PreserveBrookline-SBNA's Response to the 40B Proposal to Expand Hancock Village

40B proposal to expand Hancock Village

Current 40B proposal to expand
Hancock Village:

Too Close

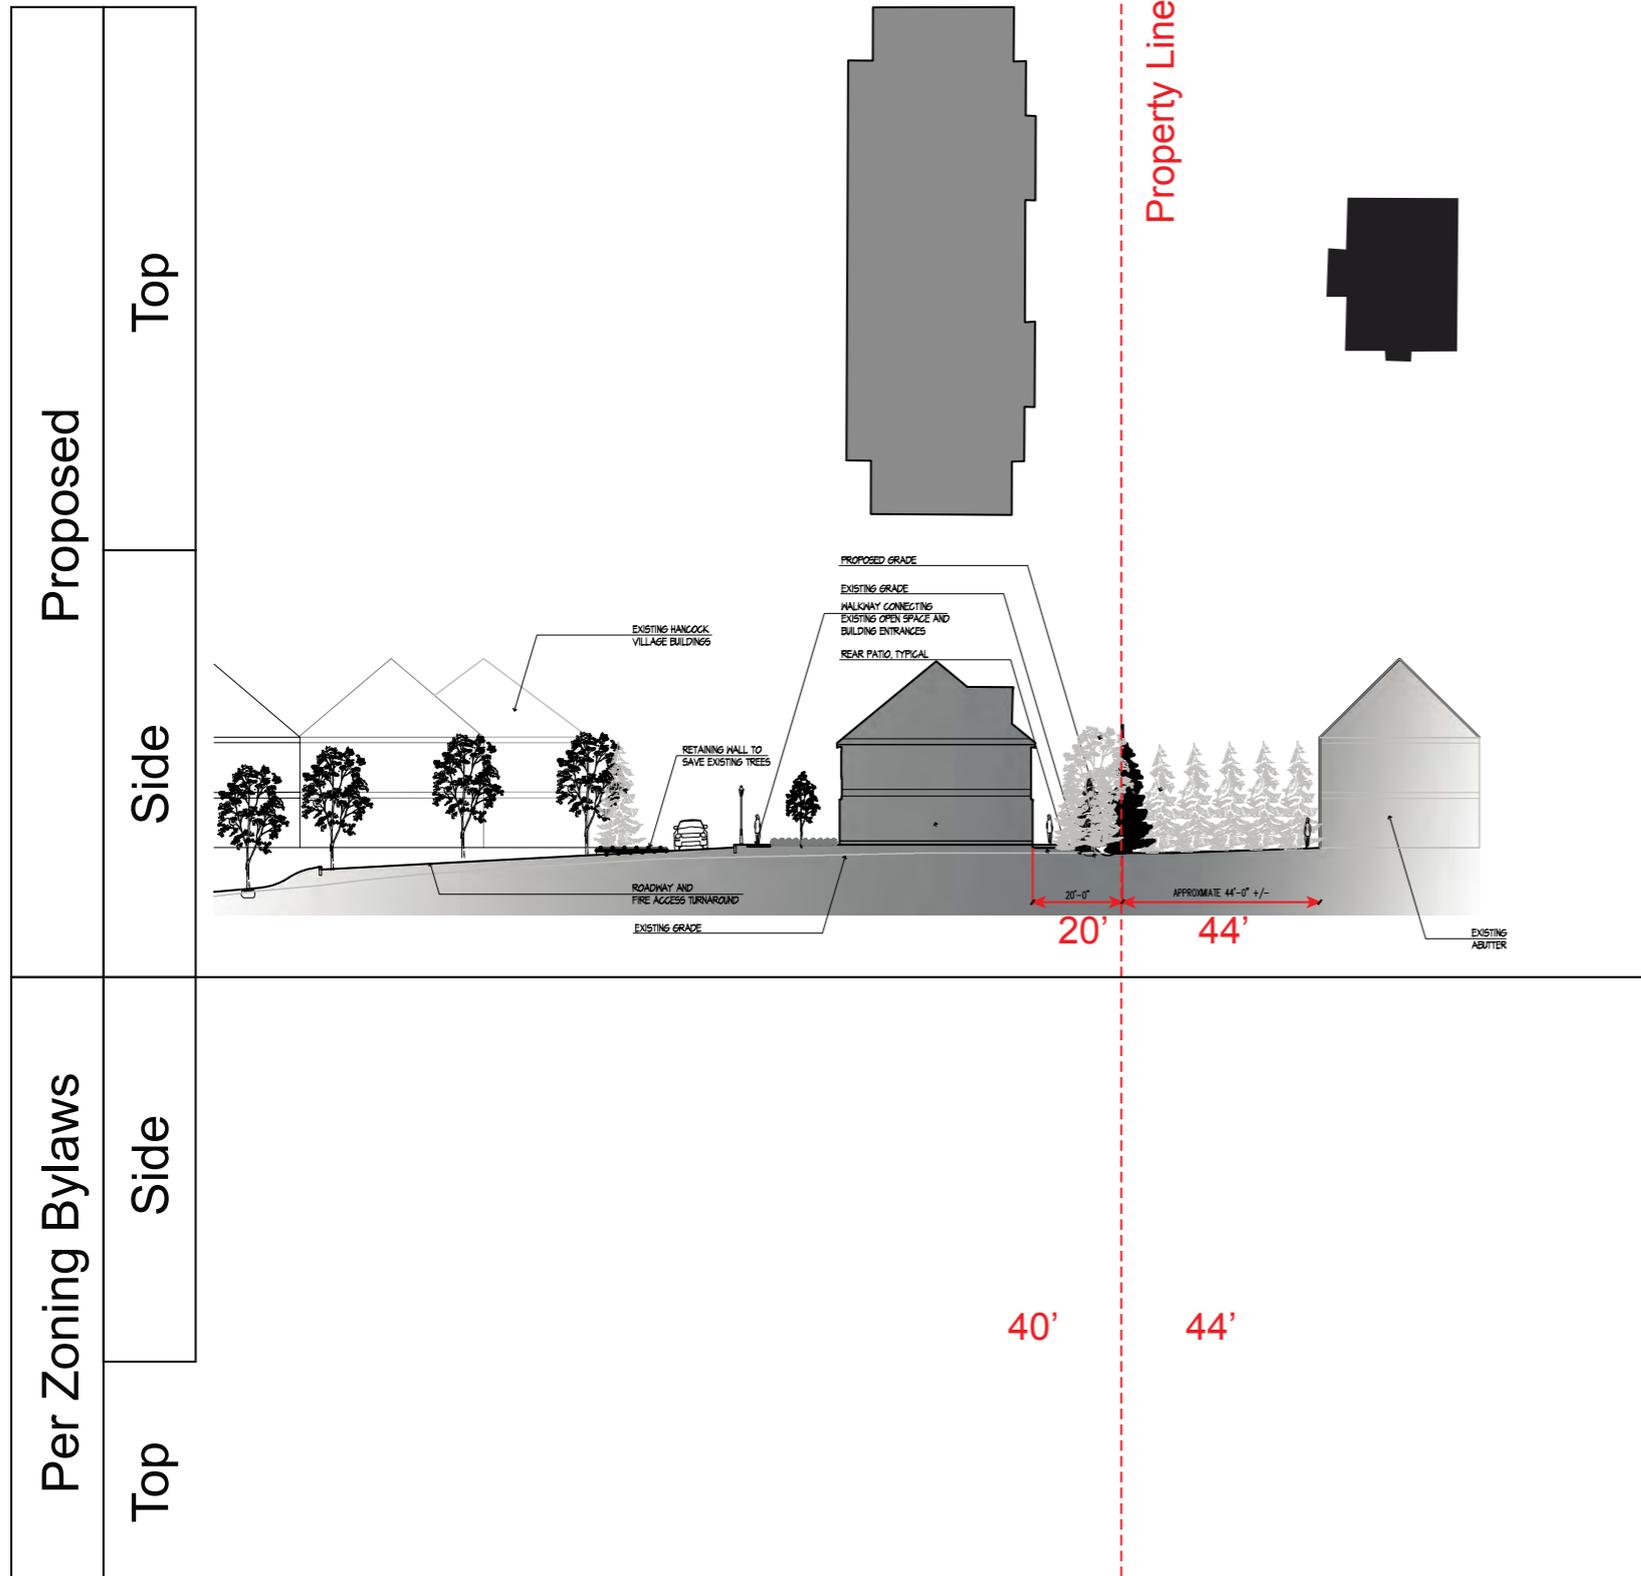
These views show how the massive building crowds the property line, placing a 2.5 story tall, 3 house long wall immediately behind the abutting home.

Too Close

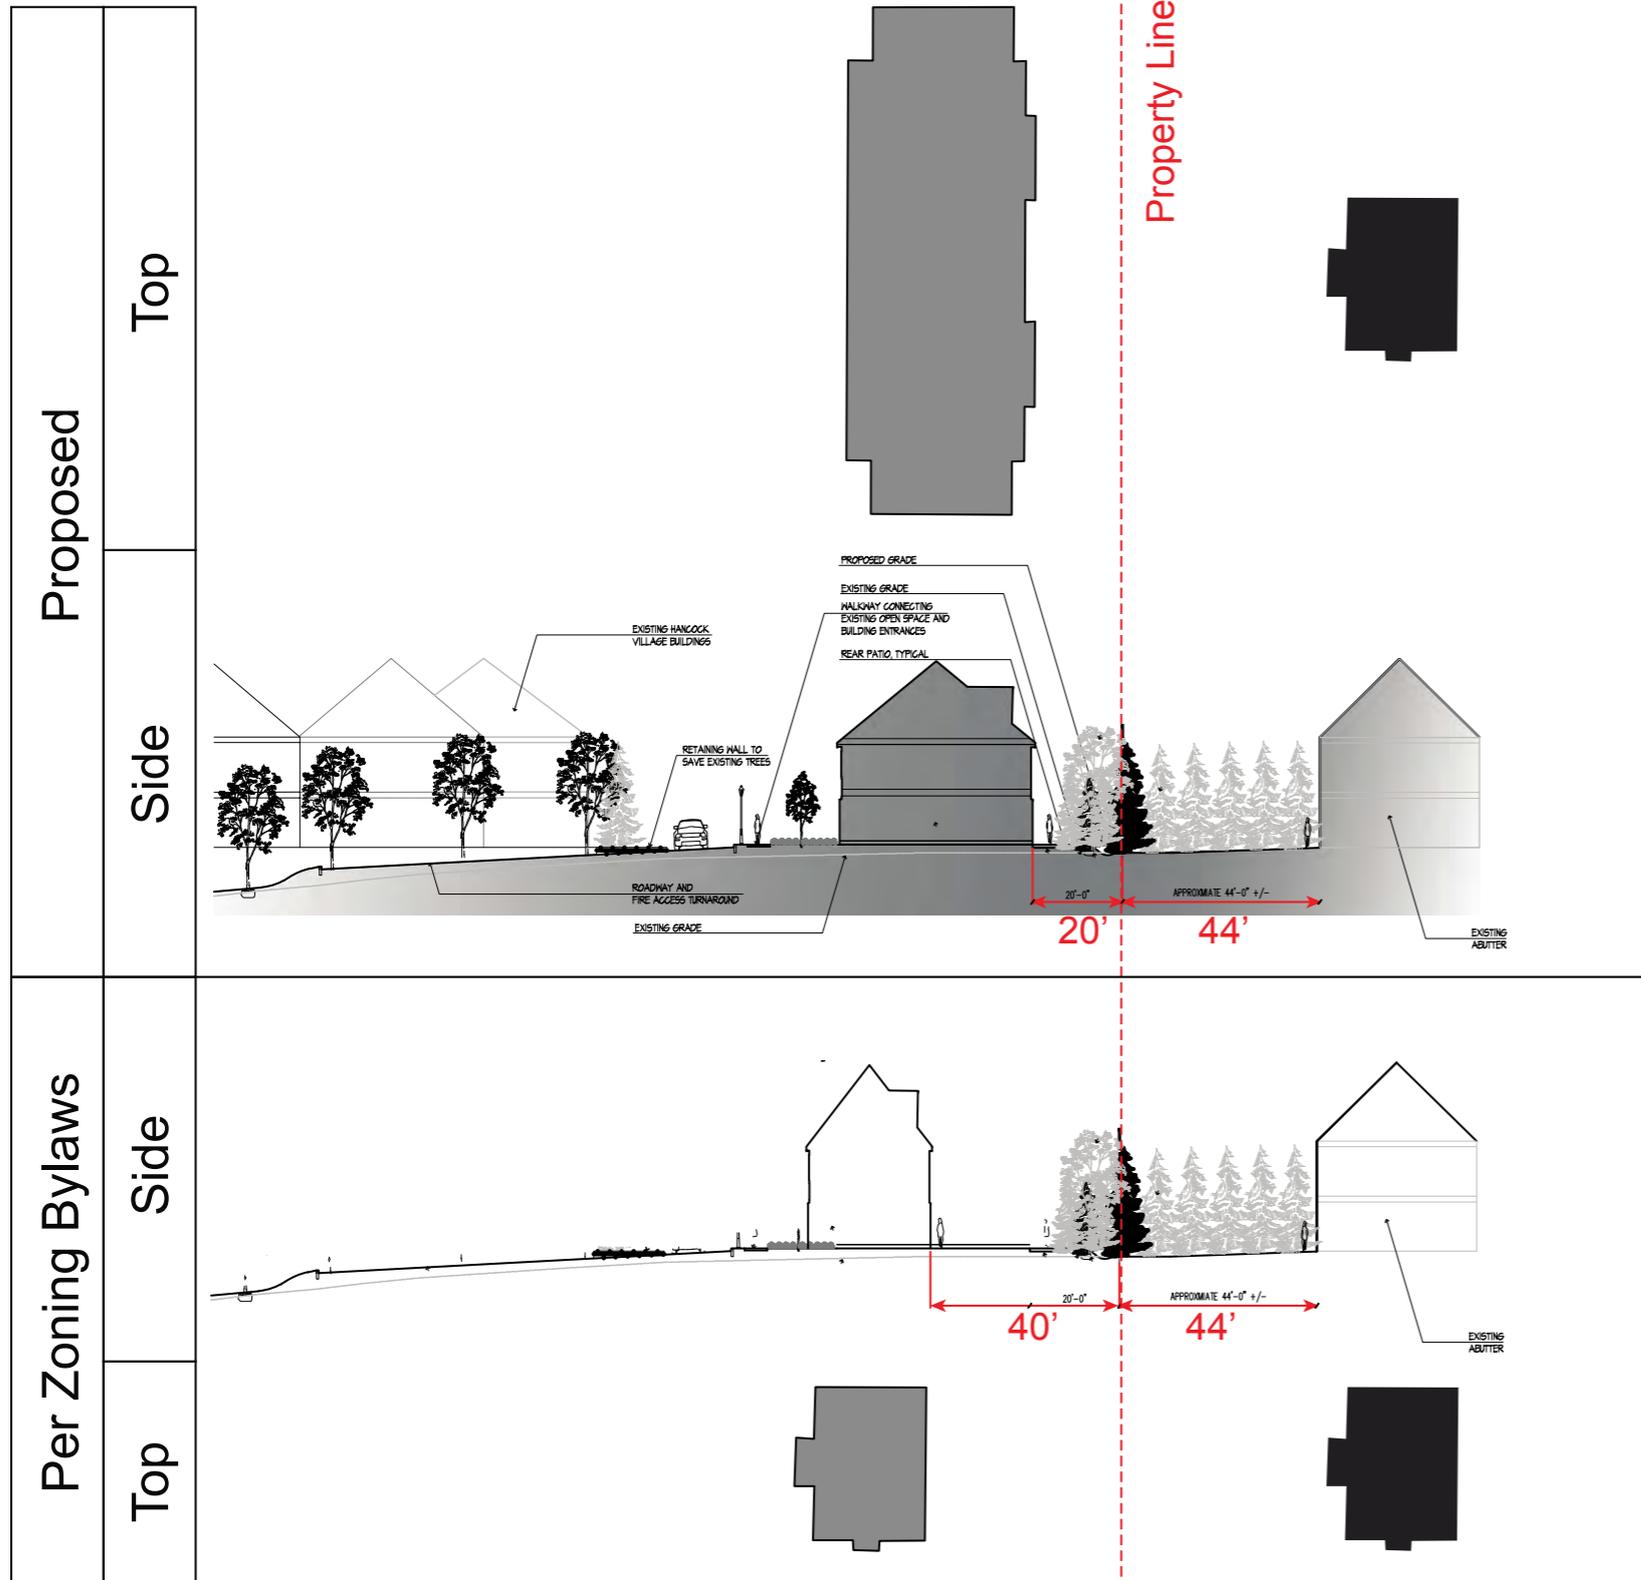
These views show how the massive building crowds the property line, placing a 2.5 story tall, 3 house long wall immediately behind the abutting home.

Compare to the relationship that would exist under normal zoning (same scale).

Loss of Greenbelt

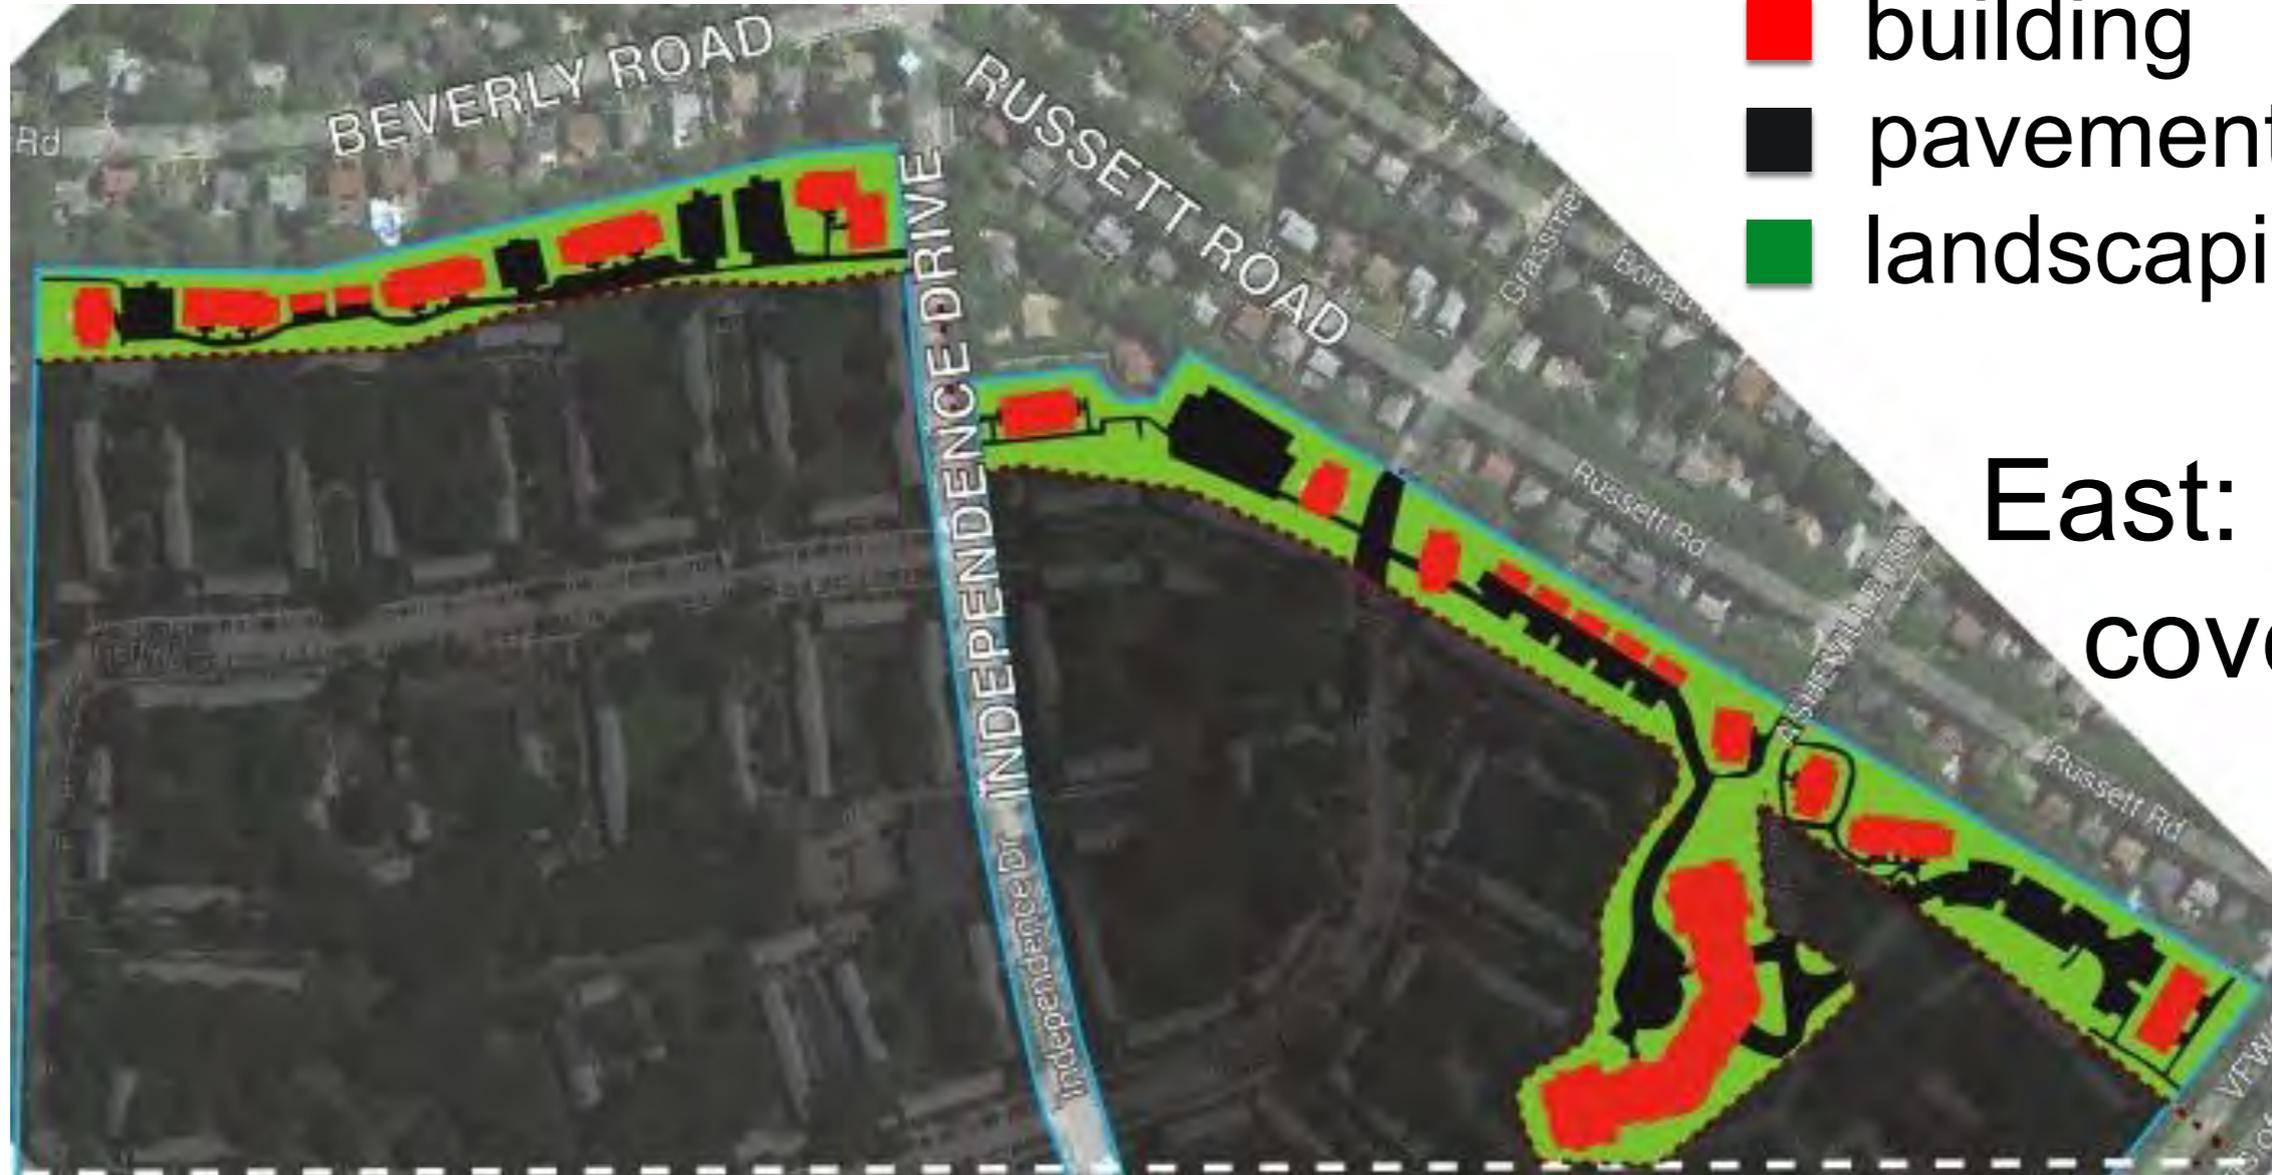
- Designed as a well-planned buffer to provide a gentle transition from multi-family to single family housing.
- Communal space for HV.
- Open space enjoyed by entire neighborhood.
- Integral to the successful design of HV.

Most of the greenbelt is paved over,
The rest is diced up into small unuseable regions.

Water

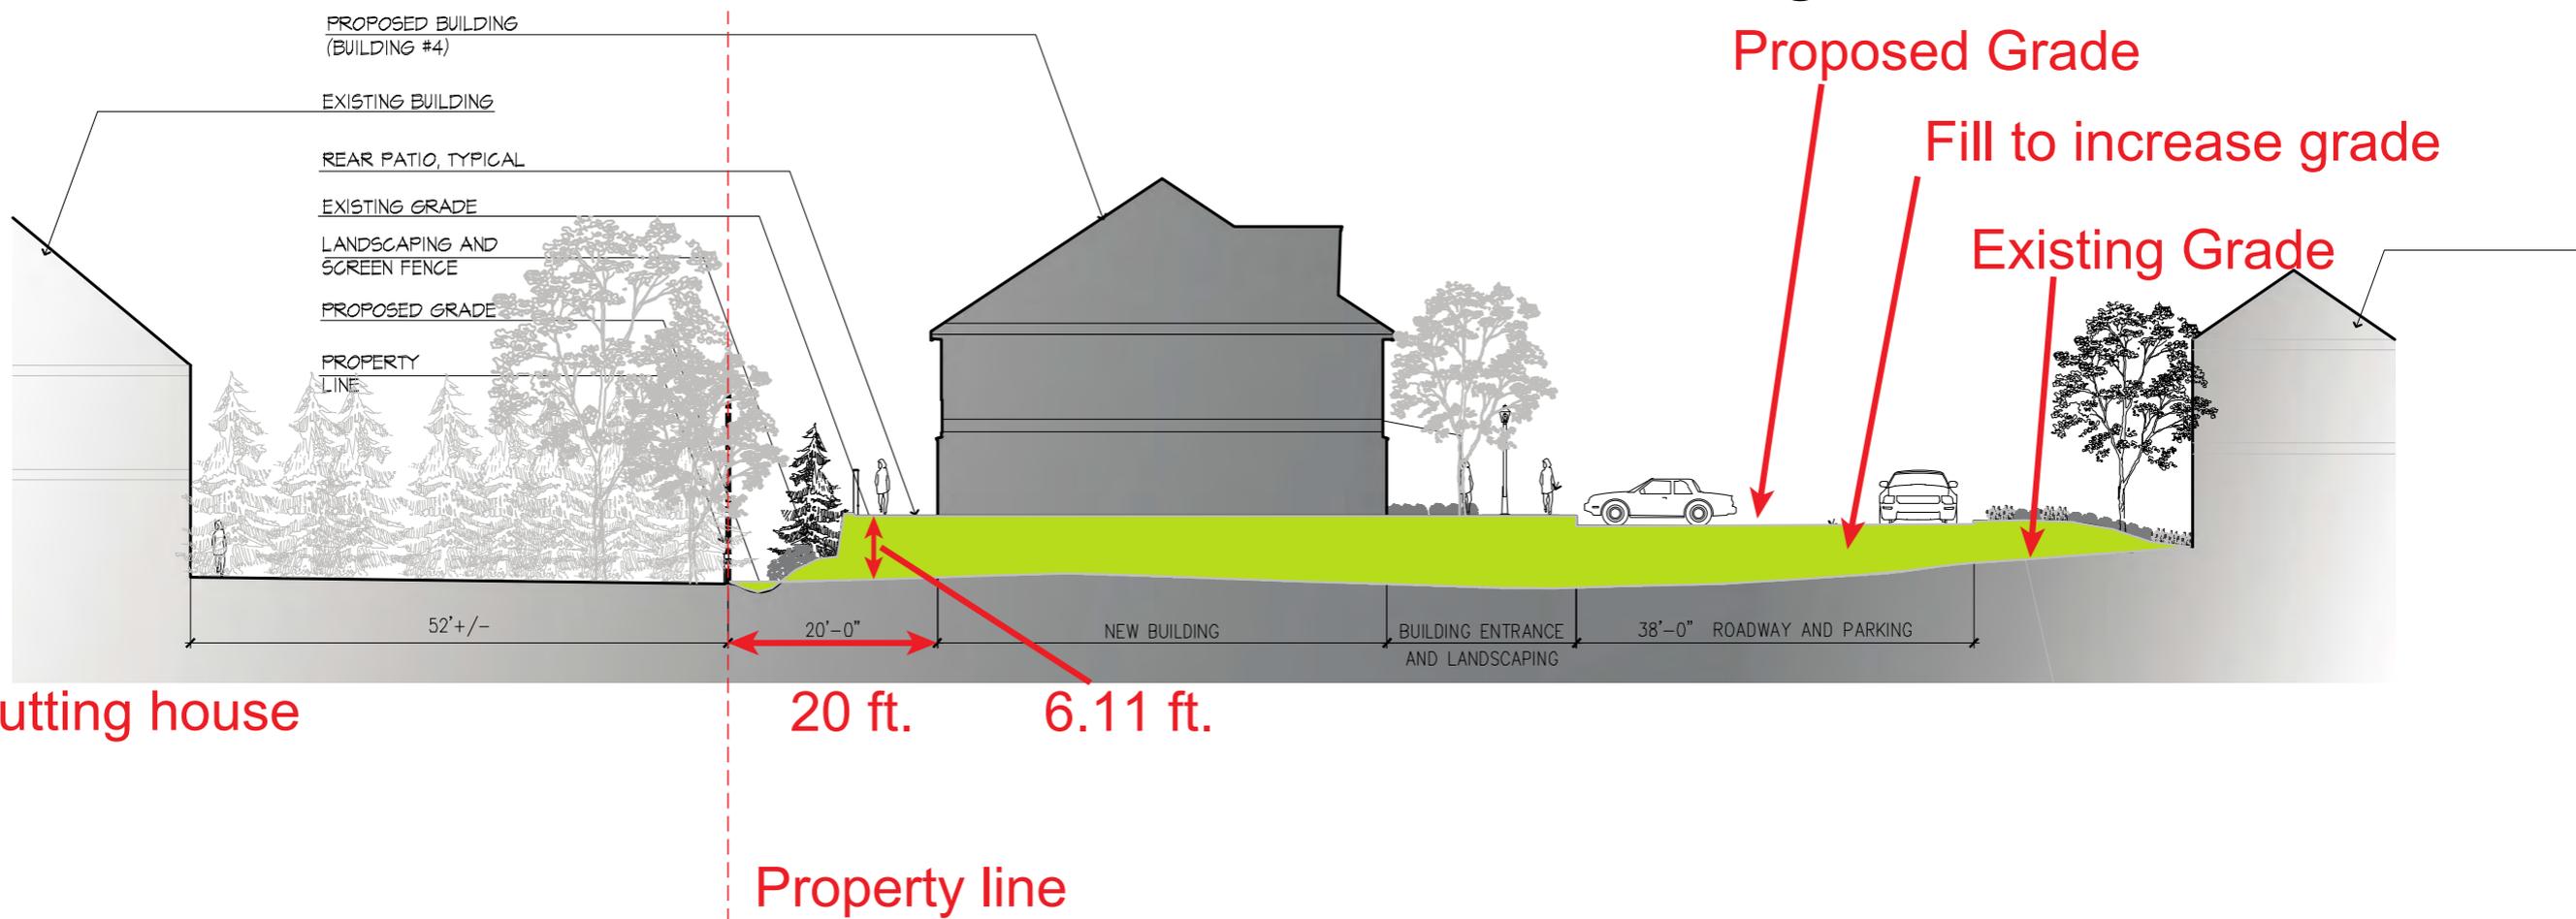
Extensive re-grading is proposed, with 4-7+ ft tall retaining walls at the edge of the property. Will cause **water problems** for neighbors.
